**ZONING AMENDMENT &
SUBDIVISION STAFF REPORT****Date: November 2, 2017**

<u>NAME</u>	David Shumer
<u>SUBDIVISION NAME</u>	Meadows Electric Subdivision
<u>LOCATION</u>	812, 816, 818, 820 and 822 Holcombe Avenue (Northside of Holcombe Avenue, 50'± West of Euclid Avenue.)
<u>CITY COUNCIL DISTRICT</u>	District 5
<u>PRESENT ZONING</u>	R-1, Single-Family District and B-3, Community Business District
<u>PROPOSED ZONING</u>	B-3, Community Business District
<u>REASON FOR REZONING</u>	To eliminate split zoning.
<u>AREA OF PROPERTY</u>	1 Lot / 1.6 ± Acre
<u>CONTEMPLATED USE</u>	<p>Subdivision approval to create one (1) legal lot from two (2) metes-and-bounds parcels and a vacated right-of-way; and Rezoning from R-1, Single-Family Residential and B-3, Community Business District to B-3, Community Business District to eliminate split zoning.</p> <p>It should be noted, however, that any use permitted in the proposed district would be allowed at this location if the zoning is changed. Furthermore, the Planning Commission may consider zoning classifications other than that sought by the applicant for this property.</p>

DETAIL SITE PLAN

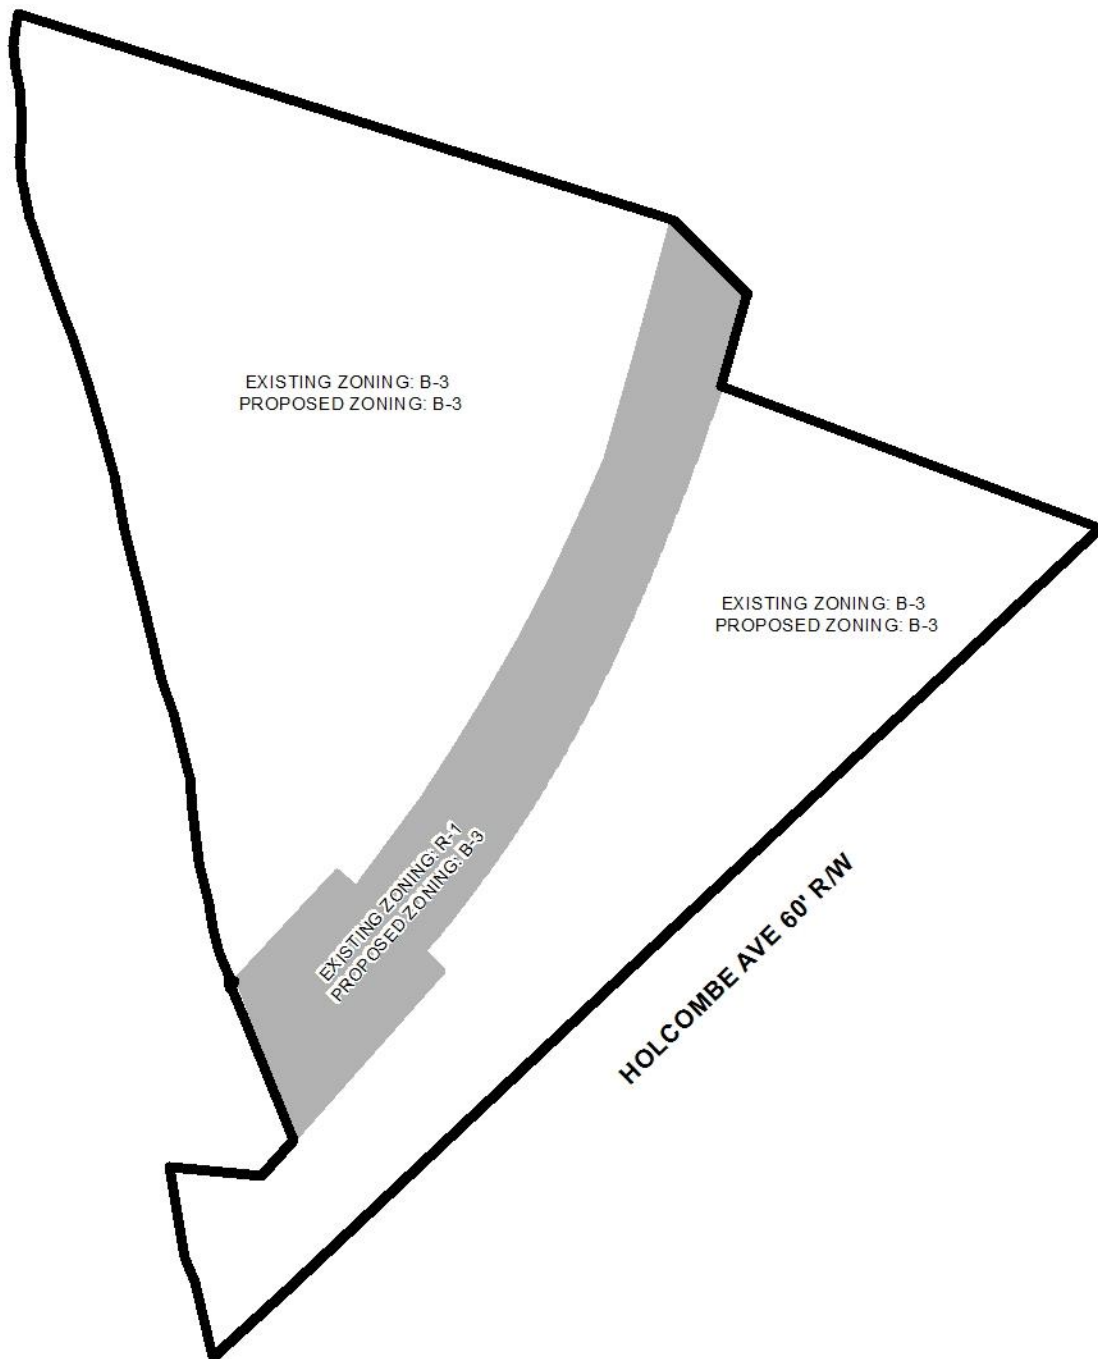
- bearings and distances) that is required by the current Alabama State Board of Licensure for Professional Engineers and Land Surveyors.
- B. Correct the street names in the vicinity map.

- C. Add Holcombe Ave and Dauphin Island Parkway to the vicinity map.
 - D. Provide a note that a 25' riparian buffer may be required, during development, along the edge of anything considered by ADEM to be a water of the state.

- E. Revise the written legal description to include a written bearing and distance for the exterior boundary of the proposed subdivision.
 - F. Revise the plat to label each lot with its size in acres and square feet, or the furnishing of a table on the Plat providing the same information.

- G. National Wetlands Inventory (NWI) mapping, as shown on City of Mobile GIS information, indicates that there is potential for wetlands within the property or properties shown on this plat. Show and label the delineated wetlands, or provide a note that the wetlands shown on this plat are scaled from the NWI data and have not been delineated.

- H. Show and clearly label all flood zones to distinguish them from the reference point tie line or the line labeled as top of bank.
 - I. Show and label the MFFE (Minimum Finished Floor Elevation) on each lot that contains an AE, V, or X (shaded) flood zone designation.

- J. Delete General Note #3. Show and label each and every Right-Of-Way and easement.
 - K. Show and label the tie line between the two (2) reference points.

The proposed lot fronts Holcombe Avenue and is bounded on the West by Eslava Creek. Holcombe Avenue is a minor street requiring a 60' right-of-way width. The preliminary plat illustrates a compliant 60' right of way width and, if approved, should be retained on the Final Plat.

The site has a continuous curb-cut along Holcombe Avenue. As the site is vacant, and as the site has 343'± of frontage, the site should be limited to two curb cuts.

The lot size is labeled in both square feet and acres for each metes-and-bounds parcel. If approved, the Final Plat should be revised to provide the lot size information for the proposed lot in square feet and acres.

The preliminary plat does not provide minimum building setback lines. If approved, 25' minimum building setbacks should be illustrated on the Final Plat along Holcombe Avenue.

- 1) Provision of the 25-foot minimum building setback line along Holcombe Avenue;
- 2) Retention of 60’ right-of-way width to Holcombe Avenue;
- 3) Provision of the lot size information in both square feet and acres;
